SUBJECT: Operation Procedures for the transmission of fax messages while making memory copies.

SUBJECT: ROM History (AD1-FAX option)

We inform you of the firmware history for the AD1-Fax option.

Model: AD1		Date: 30-Apr-97	No: 30												
Subject: Bracket for the handset option		Prepared by: K.Ugaeri													
From: QAC 2nd Field Information Dept.		Checked by: S. Fujii													
Classification:

4.HANDSET

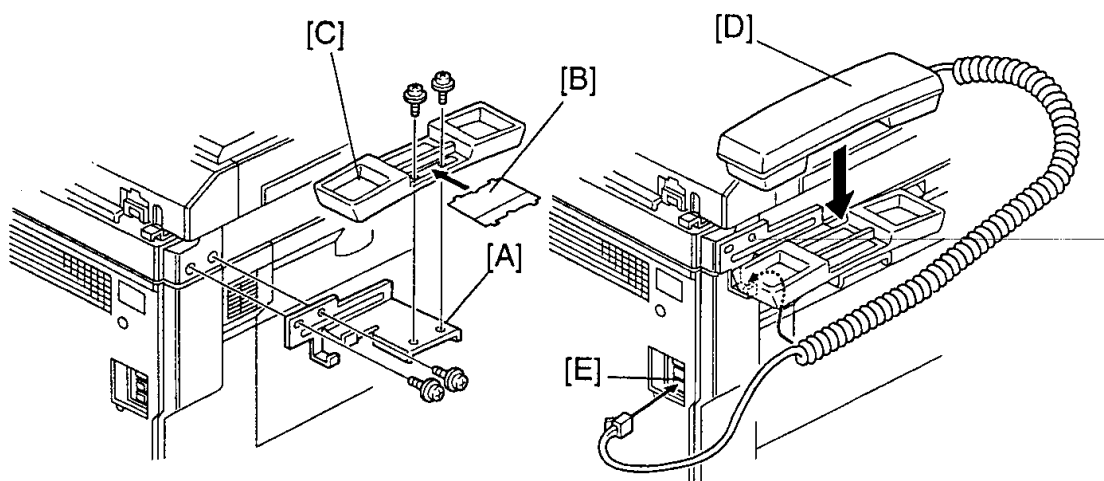
In some countries, the optional handset is available for the Aficio 200.

To install the optional handset, use the bracket which is included in the Fax Unit Option, Type 250. Also, correct the installation procedure in the Service Manual on page 3-12 as follows.

1. Install the bracket [A] (2 screws), as shown.

* The bracket [A] in the carton box of the Fax Unit Option Type 250 must be used.

2. Remove the label [B] from the handset cradle [C]. Install the cradle on the bracket [A] (2 screws), then replace the label [B].

3. Install the handset [D] as shown. Connect the handset cord to the " TEL " jack [E] on the machine.
